TECHNICAL BULLETIN
Bell Helicopter **TEXTRON**

No. 222-01-168

MODEL AFFECTED: 222 and 222B

SUBJECT: FUEL VENT ASSEMBLY P/N 430-060-004-101,
INTRODUCTION OF

Figure 2. Vent Tube Installation

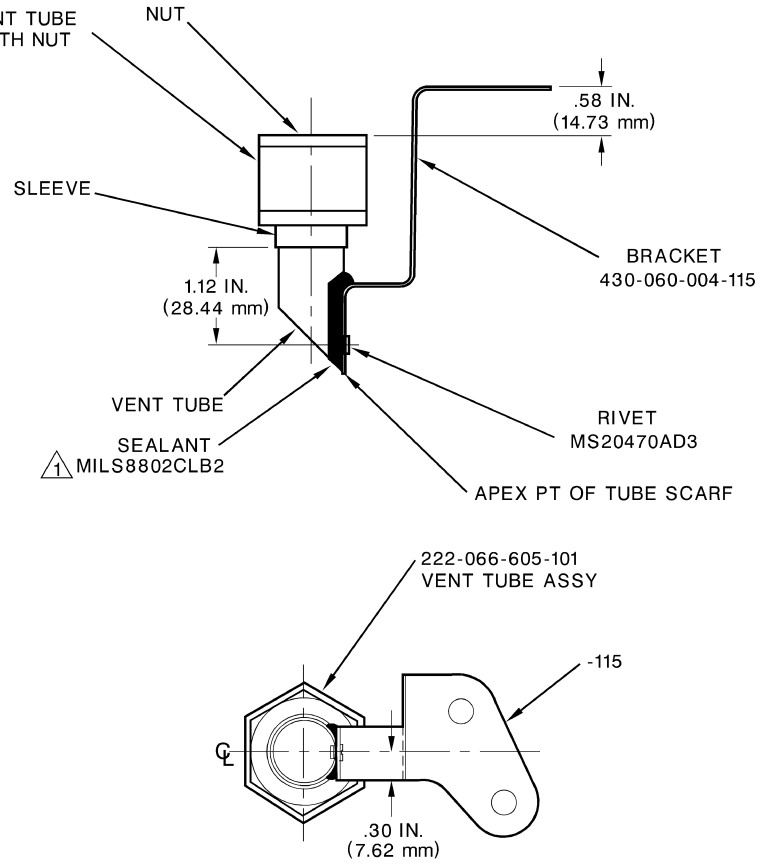
3. Remove two (2) prime pump plate retaining bolts and washers. Install modified fuel vent assembly or a new fuel vent assembly P/N 430-060-004-101 on the prime pump plate. Install retaining bolts and washers, previously removed, through the bracket and into the prime pump plate. Refer to BHT-222/222B-MM-1, Chapter 28 and figure 2.
4. Annotate aircraft records to reflect compliance with this bulletin.

Figure 1. Vent Tube Modification

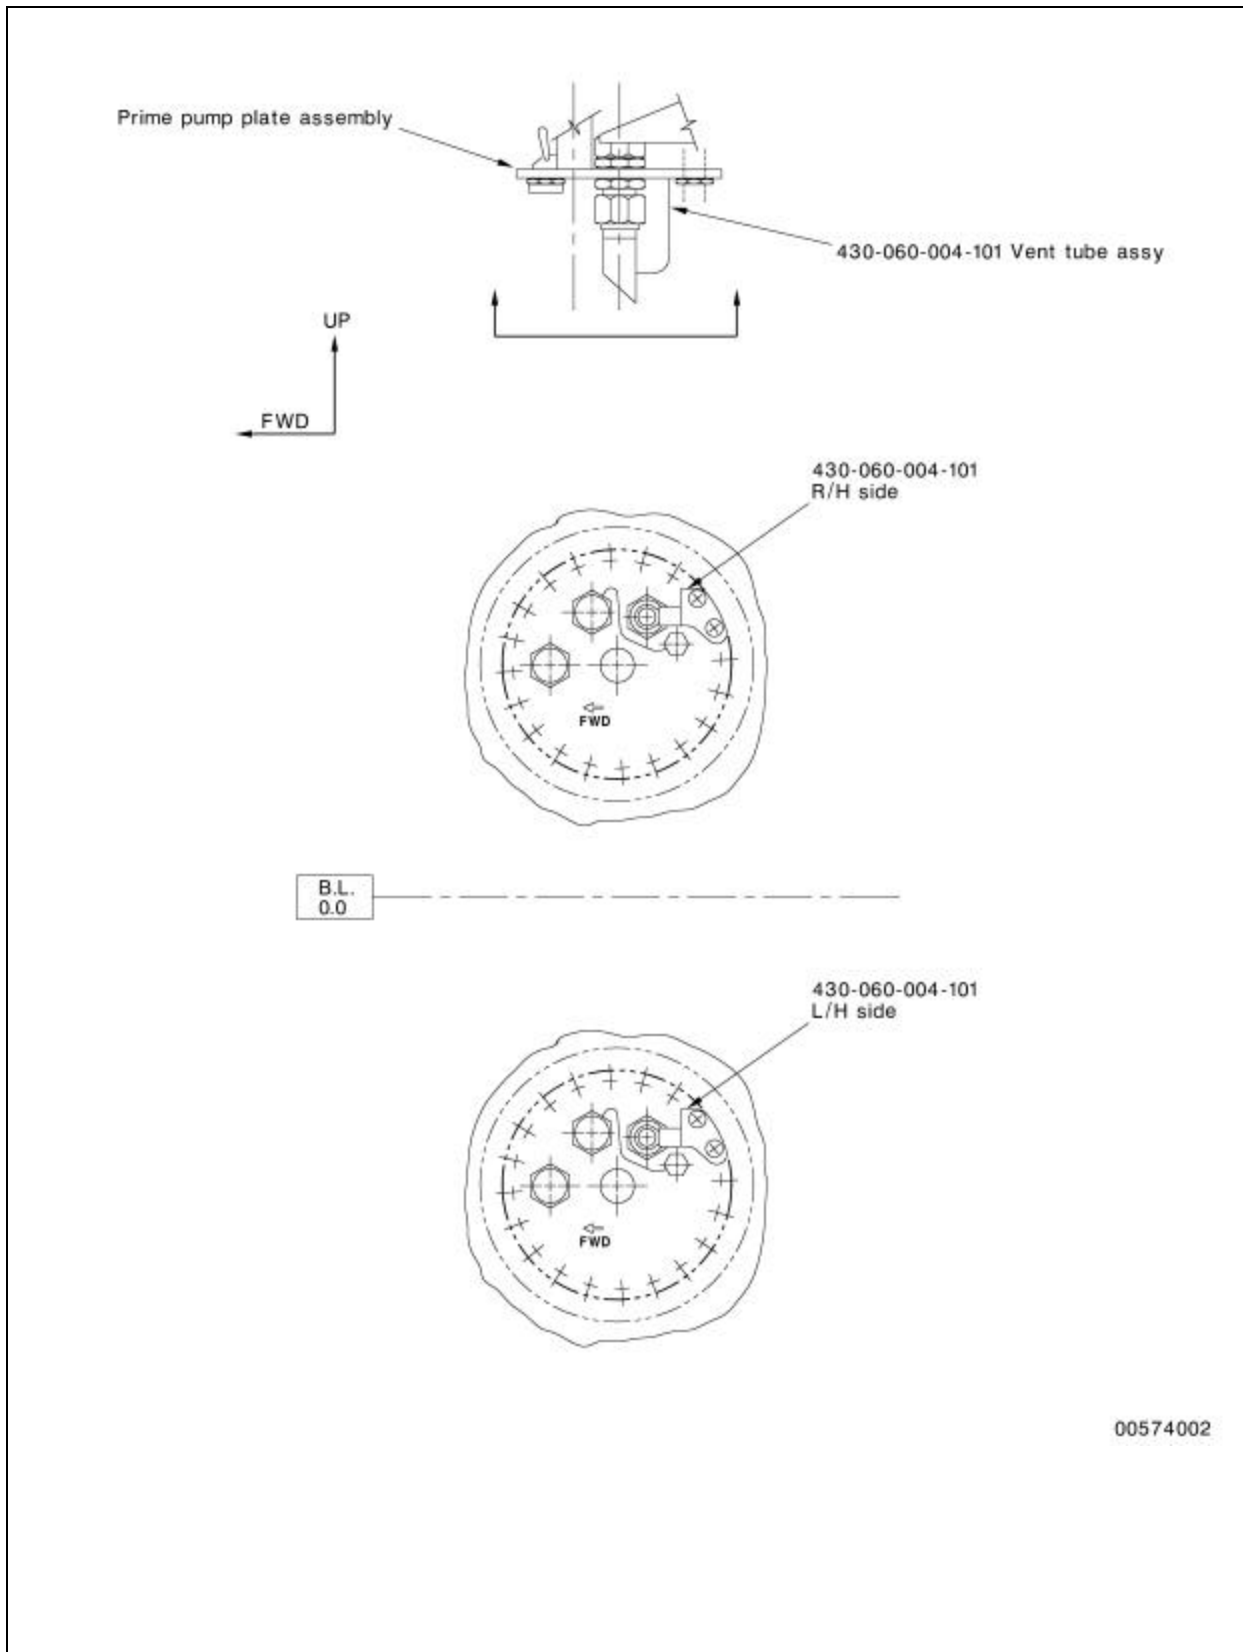
Bell Helicopter has received reports of reduced fuel capacity as a result of fuel cell distortion caused by incorrect installation of the fuel vent assembly on the prime pump plate. The fuel vent is designed to be installed with the scarf cut facing relative wind (forward). Installation of the vent with the scarf facing aft produces negative pressure on the fuel system in forward flight and may cause distortion of the fuel cell(s). The new fuel vent assembly is designed to prevent incorrect installation.

1. Remove existing fuel vent assembly P/N 222-066-605-101 from the prime pump plate. Refer to BHT-222/222B-MM-1, Chapter 28.
2. Modify fuel vent assembly as follows:
 - a) Ensure sleeve and vent tube is fully seated into the nut.
 - b) Install bracket on the vent tube using rivet MS20470AD3-length. Refer to figure 1 for details and dimensions.
 - c) Apply sealant (C-308) to fill the space between vent tube and bracket. Refer to figure 1.

ENSURE SLEEVE & VENT TUBE
ARE FULLY SEATED WITH NUT

1 Apply MILS8802CLB2 (C-308) sealant to fill space between the vent tube and the bracket.
